**ADDENDUM 3 TO BID DOCUMENTS FOR THE
BAYOU CANE MARSH CREATION PROJECT
(PO-0181)**

ST. TAMMANY PARISH, LOUISIANA

**STATE OF LOUISIANA
COASTAL PROTECTION AND RESTORATION AUTHORITY**

July 25, 2025

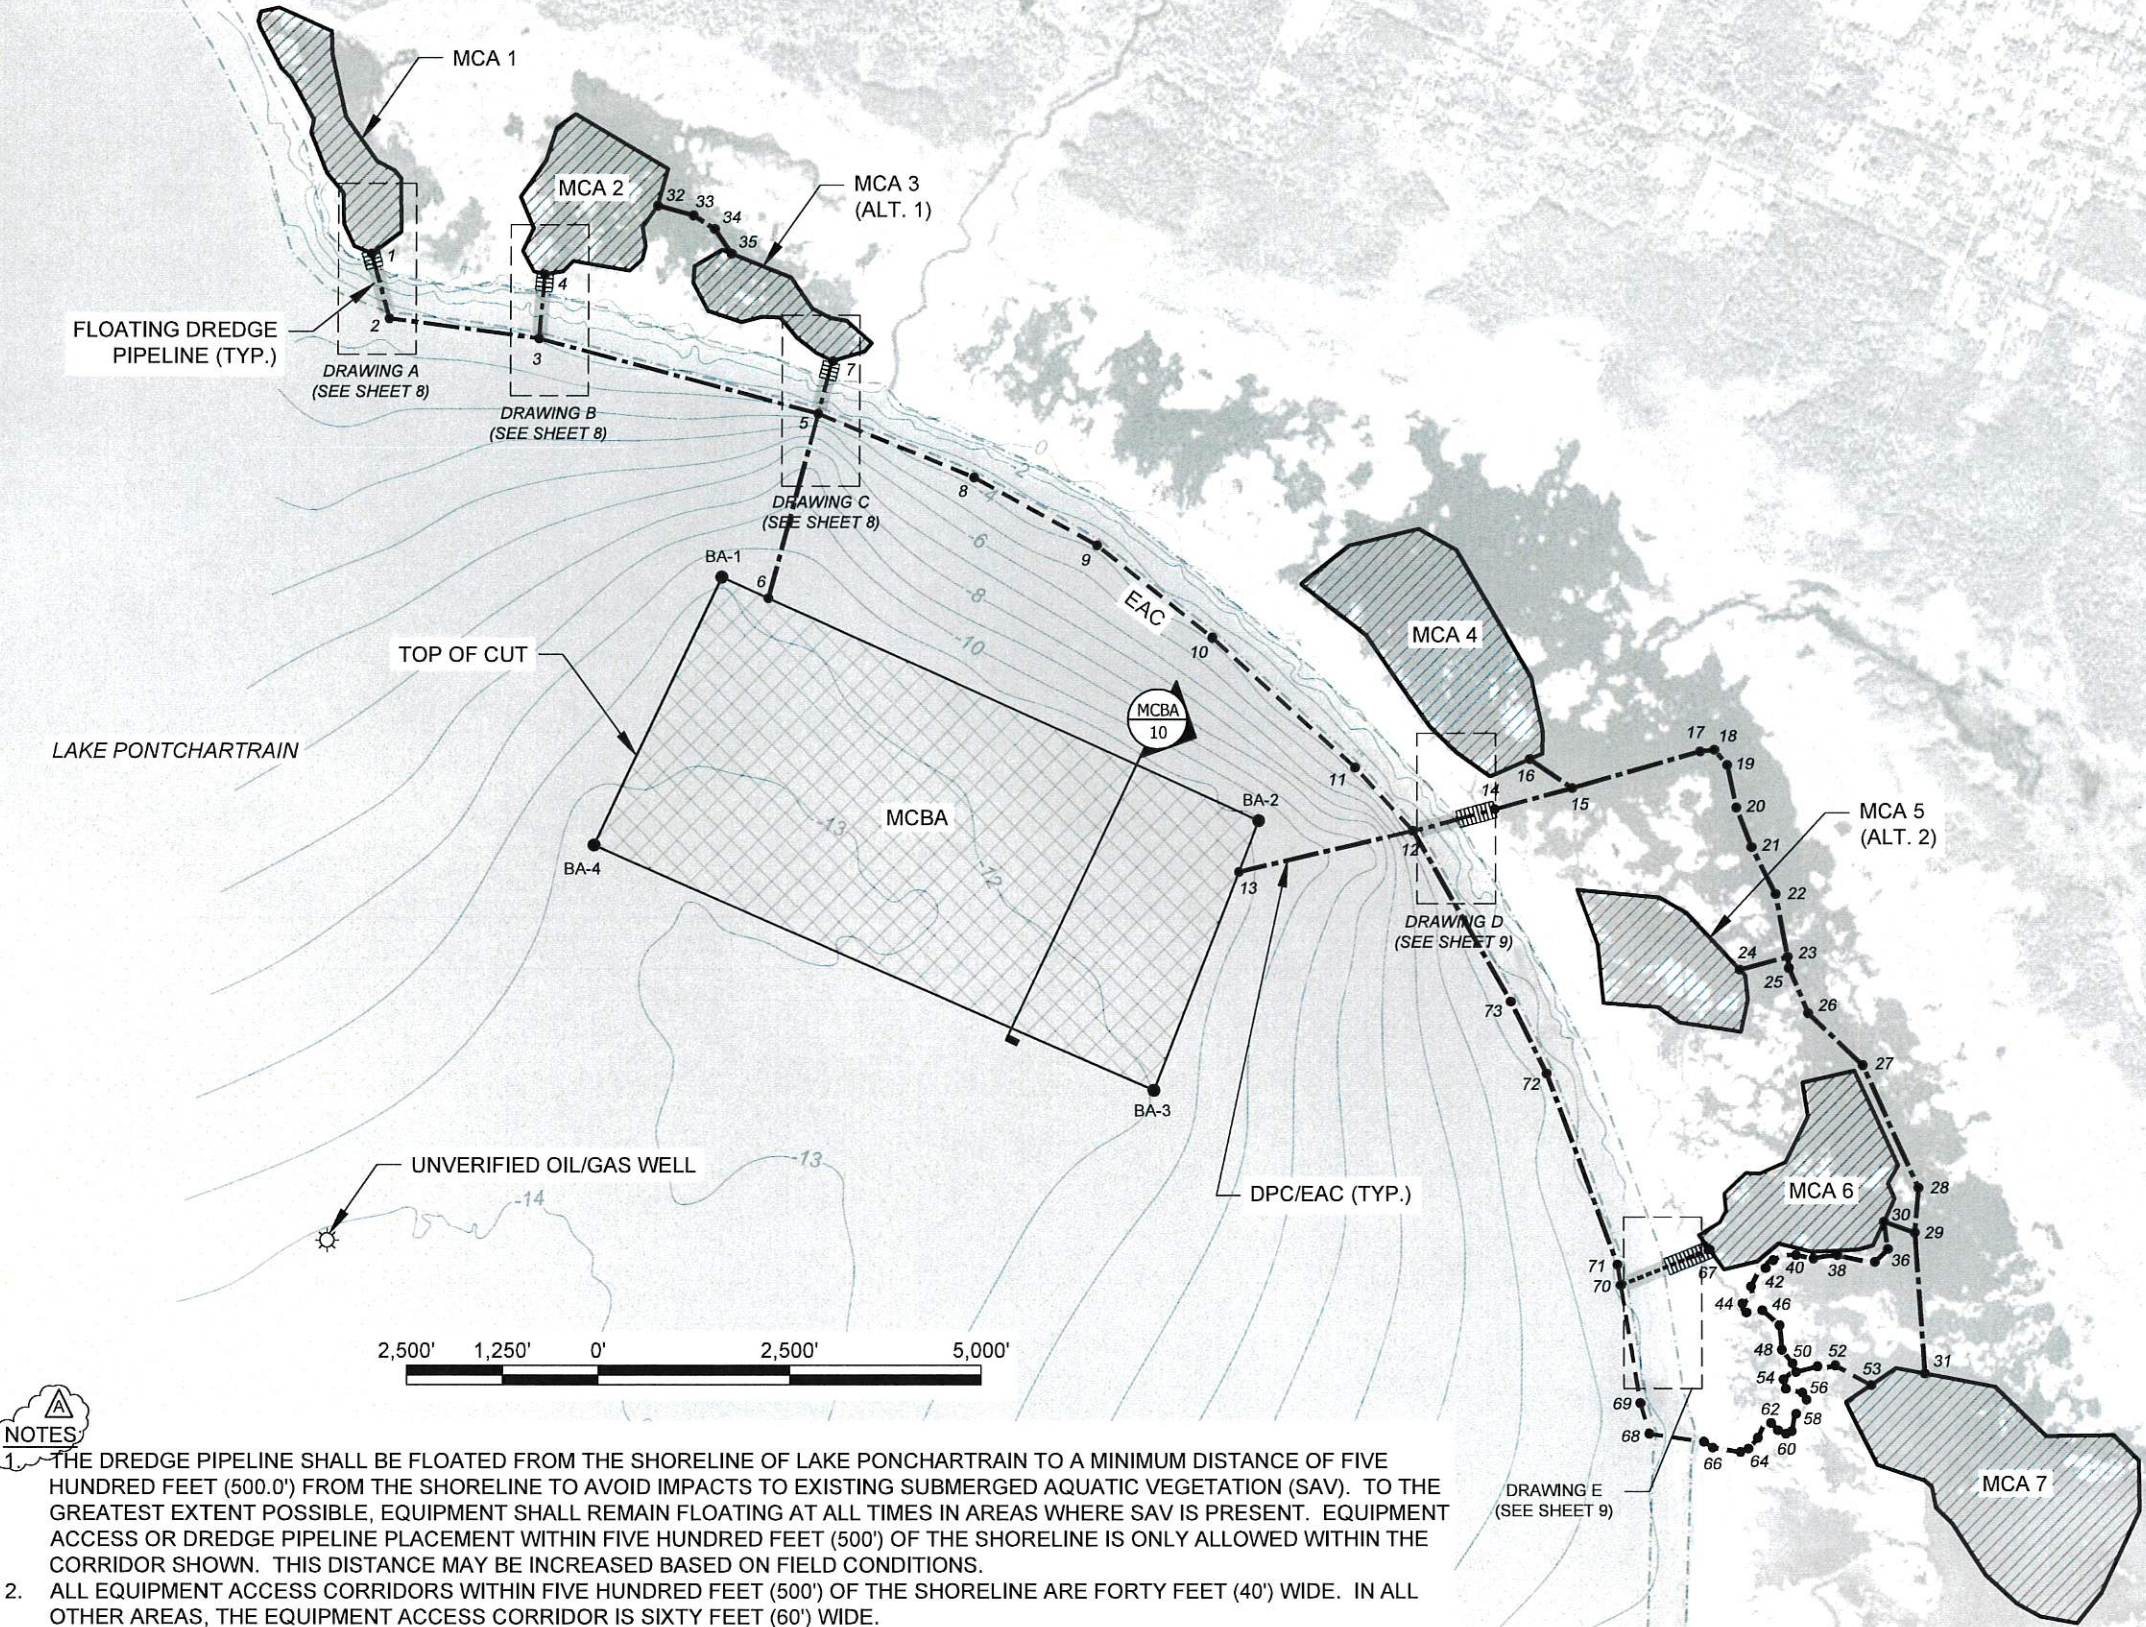
Plan Sheet 5: The location of Point 4 (near MCA-2) has been updated to the correct location.

Plan Sheets 5, 6, 7, 8, 9, and 16: A Modification to Note 1 and the note pertaining to Section DPC2 and DPC4 (Sheet 16), is represented by bold, italicized text, and is replaced in its entirety with the following:

1. THE DREDGE PIPELINE SHALL BE FLOATED FROM THE SHORELINE OF LAKE PONCHARTRAIN TO A MINIMUM DISTANCE OF FIVE HUNDRED FEET (500.0') FROM THE SHORELINE TO AVOID IMPACTS TO EXISTING SUBMERGED AQUATIC VEGETATION (SAV). TO THE GREATEST EXTENT POSSIBLE, EQUIPMENT SHALL REMAIN FLOATING AT ALL TIMES IN AREAS WHERE SAV IS PRESENT. EQUIPMENT ACCESS OR DREDGE PIPELINE PLACEMENT WITHIN FIVE HUNDRED FEET (500') OF THE SHORELINE IS ONLY ALLOWED WITHIN THE CORRIDOR SHOWN. THIS DISTANCE MAY BE INCREASED BASED ON FIELD CONDITIONS.

2. ALL EQUIPMENT ACCESS CORRIDORS WITHIN FIVE HUNDRED FEET (500') OF THE SHORELINE ARE FORTY FEET (40') WIDE. IN ALL OTHER AREAS, THE EQUIPMENT ACCESS CORRIDOR IS SIXTY FEET (60') WIDE.

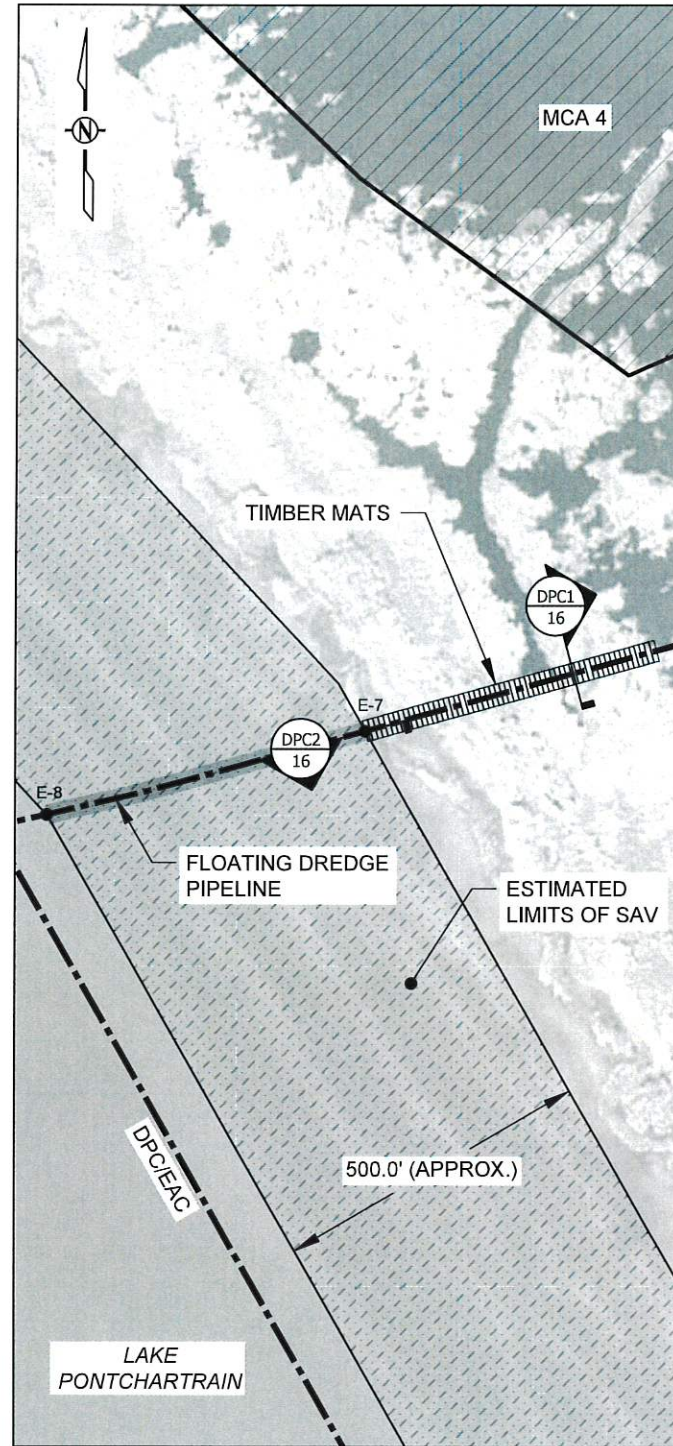
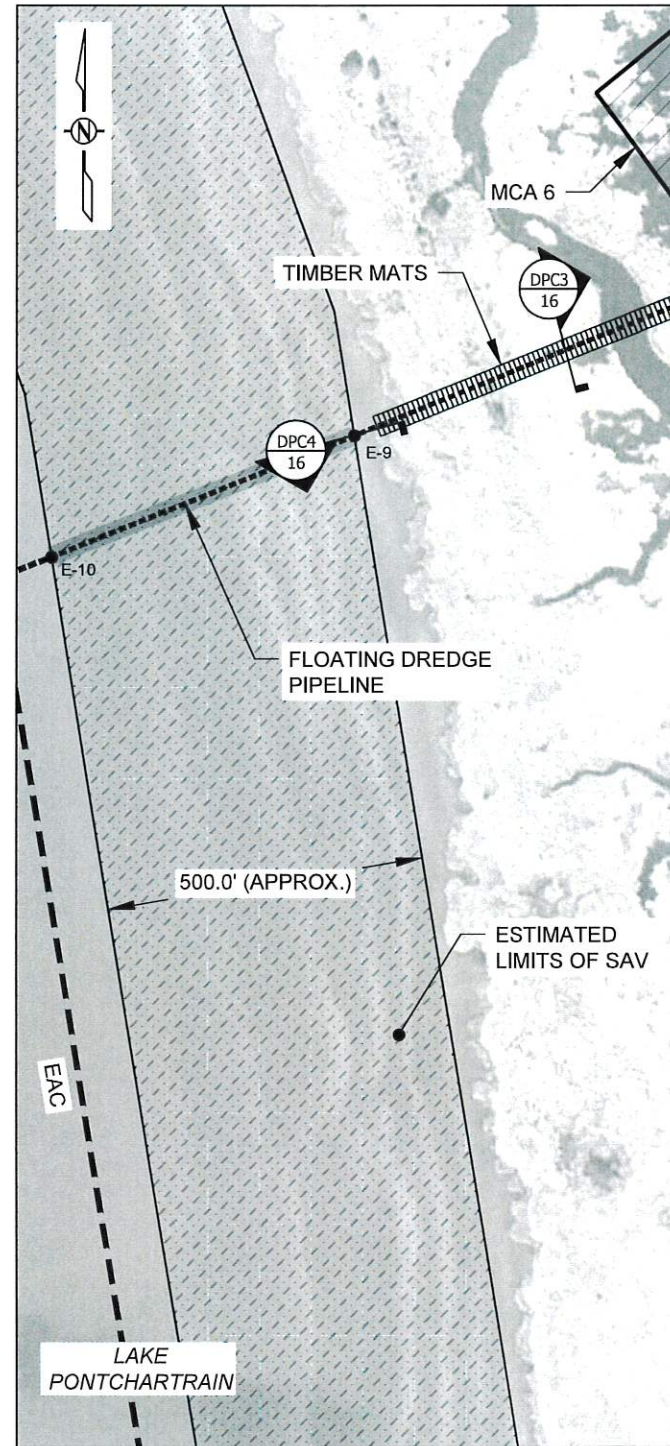
Plan Sheet 9: The location of points E-7, E-8, E-9, and E-10 has been corrected.

1. THE DREDGE PIPELINE SHALL BE FLOATED FROM THE SHORELINE OF LAKE PONCHARTRAIN TO A MINIMUM DISTANCE OF FIVE HUNDRED FEET (500.0') FROM THE SHORELINE TO AVOID IMPACTS TO EXISTING SUBMERGED AQUATIC VEGETATION (SAV). TO THE GREATEST EXTENT POSSIBLE, EQUIPMENT SHALL REMAIN FLOATING AT ALL TIMES IN AREAS WHERE SAV IS PRESENT. EQUIPMENT ACCESS OR DREDGE PIPELINE PLACEMENT WITHIN FIVE HUNDRED FEET (500') OF THE SHORELINE IS ONLY ALLOWED WITHIN THE CORRIDOR SHOWN. THIS DISTANCE MAY BE INCREASED BASED ON FIELD CONDITIONS.

2. TIMBER MATS SHALL BE PLACED WHEN THE DREDGE PIPELINE OR THE EQUIPMENT ACCESS CORRIDOR CROSSES THE EXISTING SHORELINE OR MARSH.
3. UTILIZATION OF THE SHORELINE CROSSING INTO MCA-6 IS RESTRICTED TO THE INSTALLATION, MONITORING, SURVEYING AND DEMOBILIZATION OF DREDGE PIPELINE. EQUIPMENT ACCESS THAT IS NOT ASSOCIATED WITH THE AFOREMENTIONED ACTIVITIES WILL NOT BE PERMITTED TO UTILIZE THIS CROSSING LOCATION.

SHEET 11 OF 36

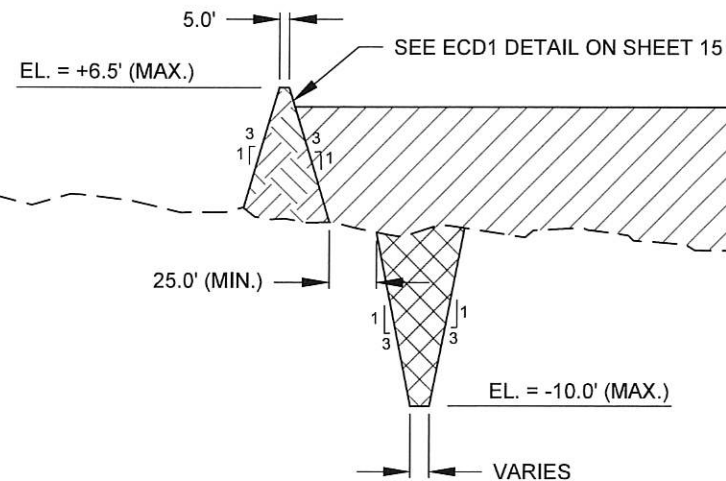
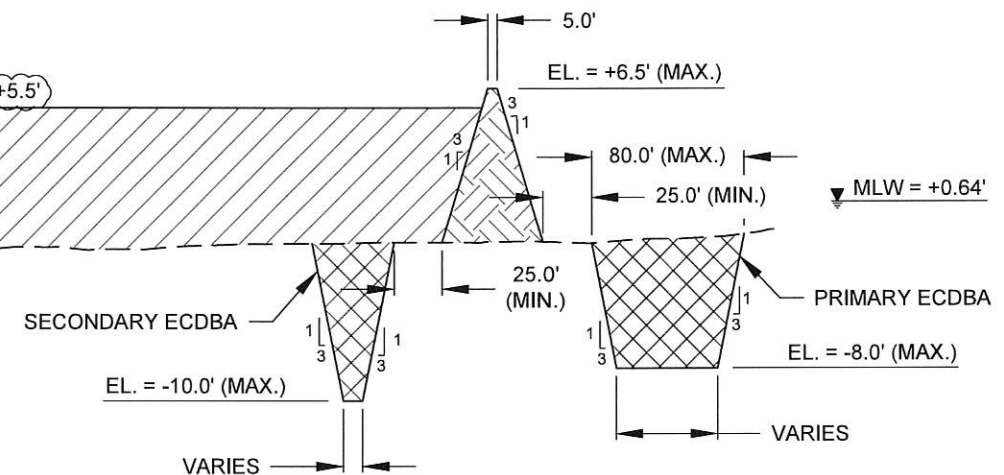
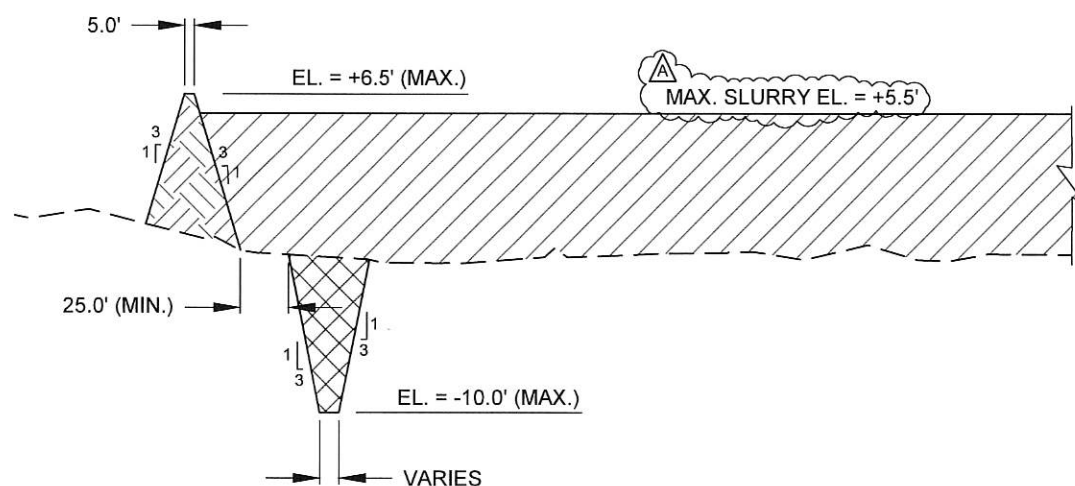
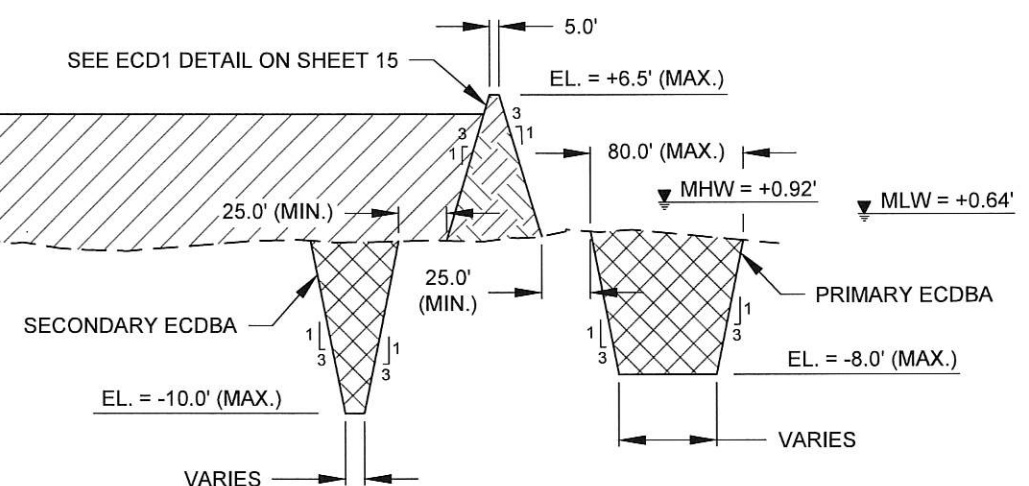
Plan Sheets 11, 12, 13, and 14: Modifications are represented by the following:
